**STATE OF TENNESSEE
DEPARTMENT OF TRANSPORTATION**

INSTRUCTIONAL BULLETIN NO. 21-20

Regarding Various Revised, New and Voided Standard Drawings

Effective May 13, 2022 letting (March 2, 2022 Turn-in), the following Standard Drawings have been revised or are new. In addition, the Roadway Design Guidelines Chapter 7 – Item Numbers, Sections 7-611.00, Manholes, Catchbasins, Inlets and Pipe End Walls, and Section 7-705.00, Guardrails, of the Roadway Design Guidelines has been modified to reflect any changes to or new item numbers in the Standard Drawings of this Instructional Bulletin.

CONNECTION KEY DETAILS

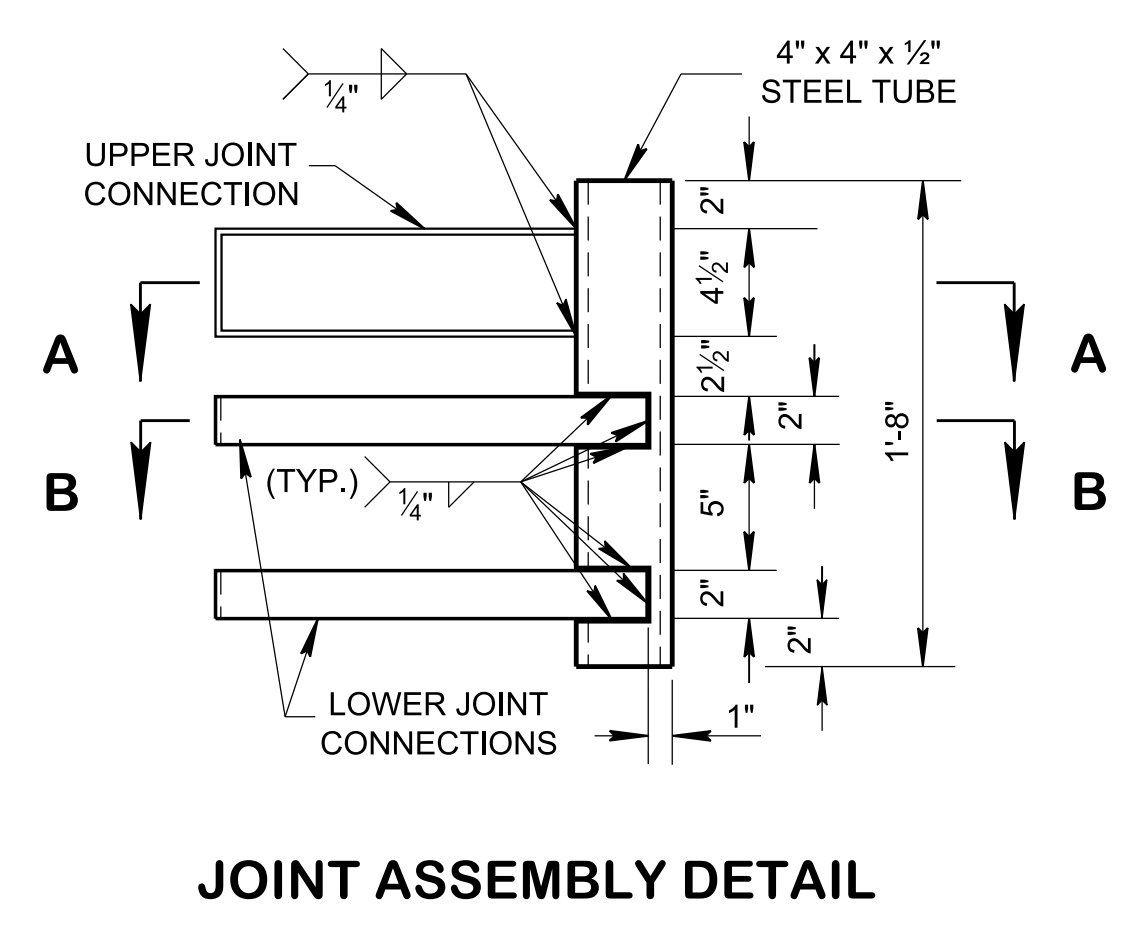
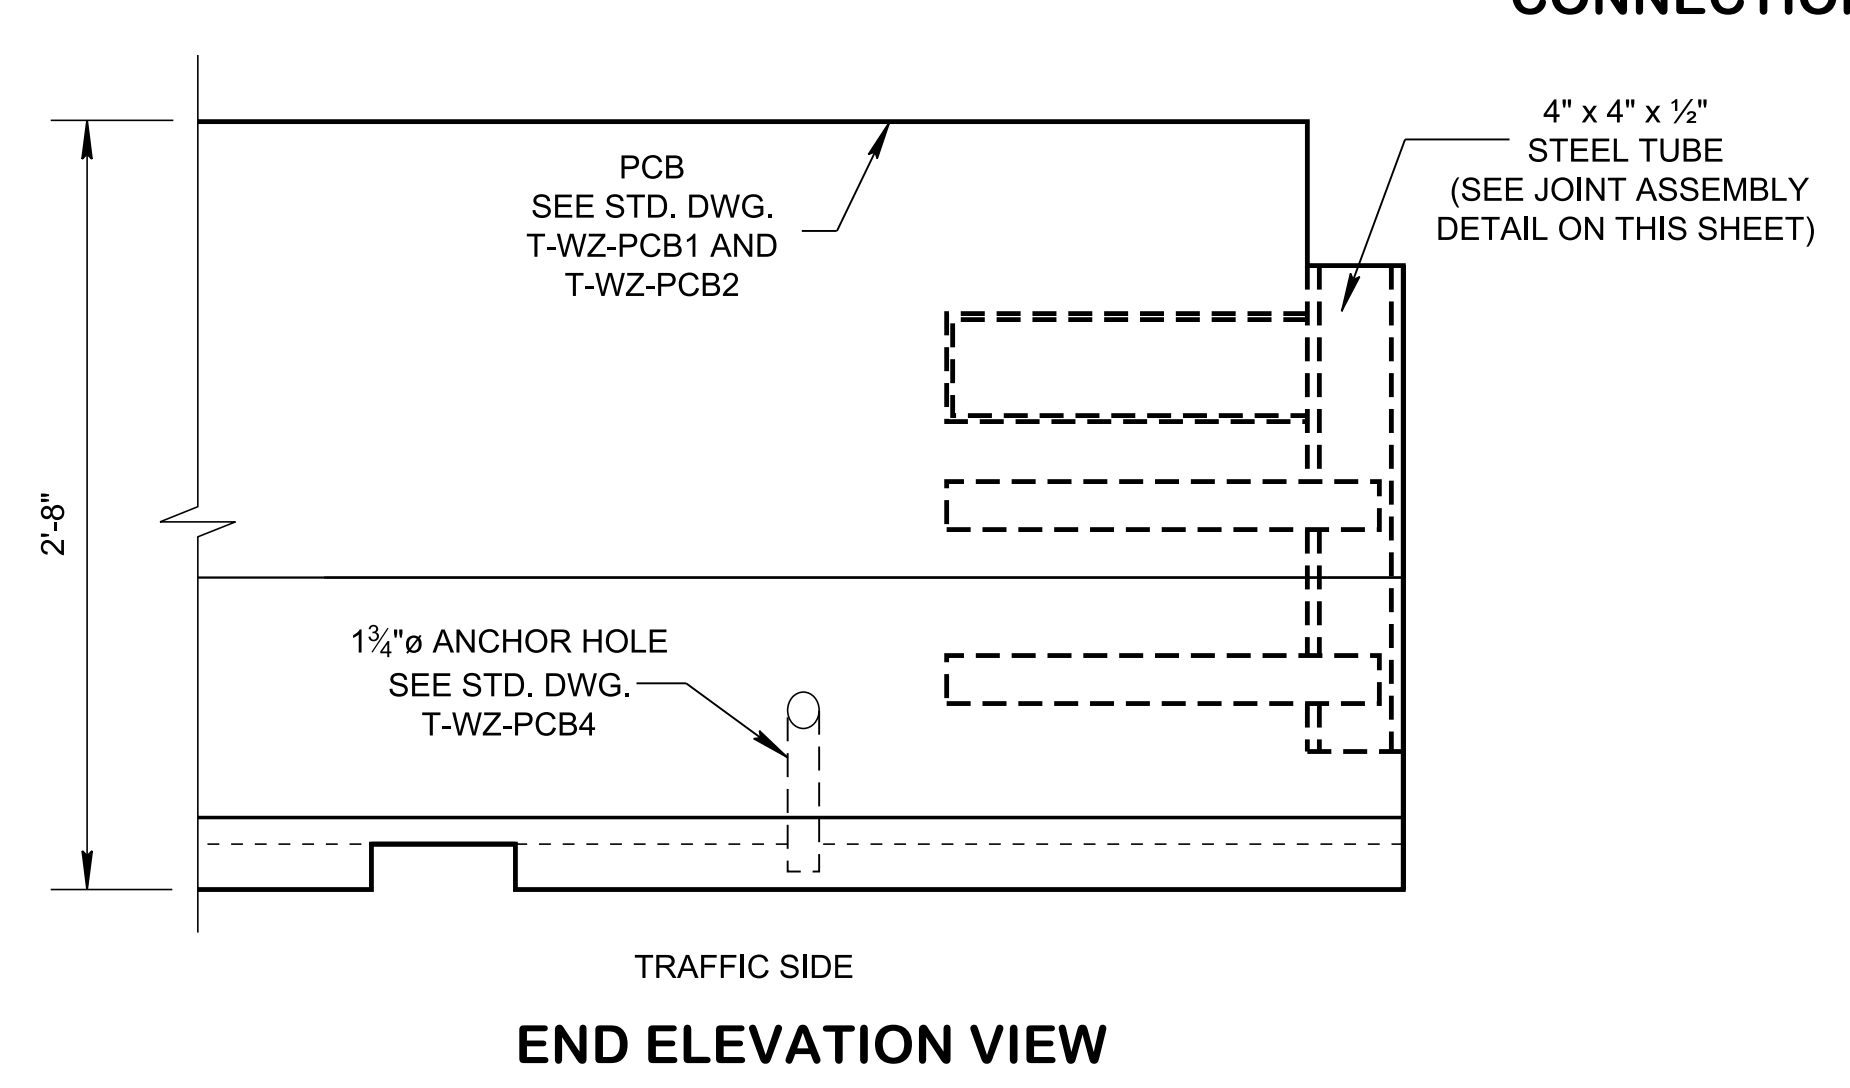
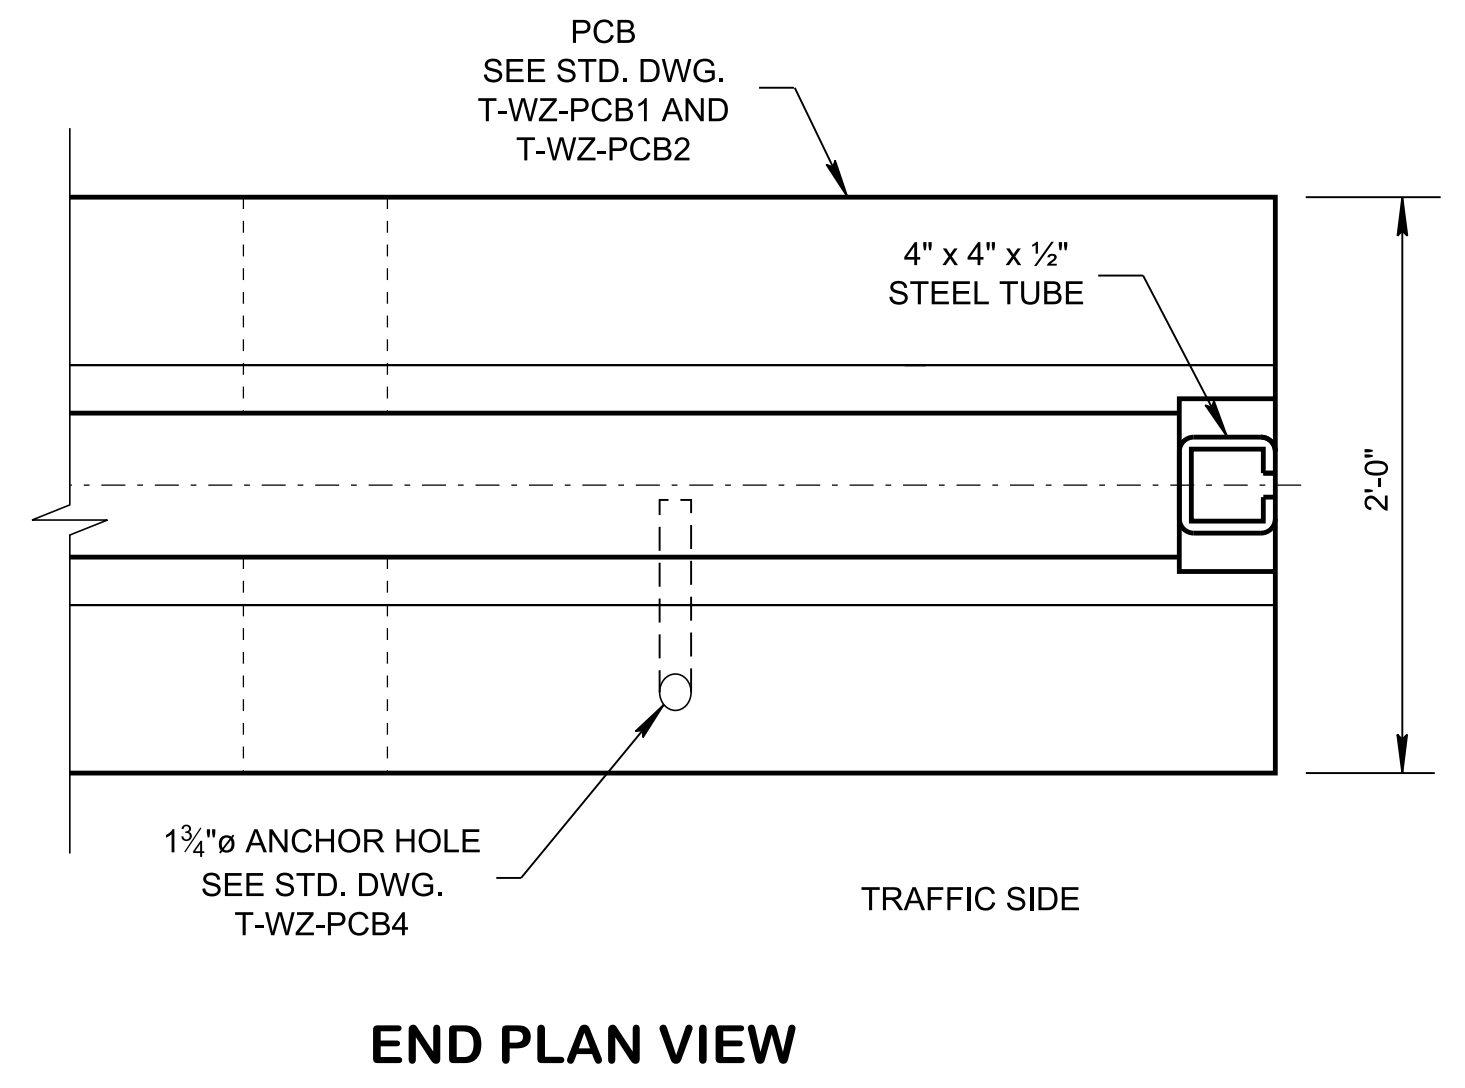
REV. 10-29-2021: ADDED ALTERNATIVE DETAIL FOR UPPER AND LOWER JOINT CONNECTIONS.
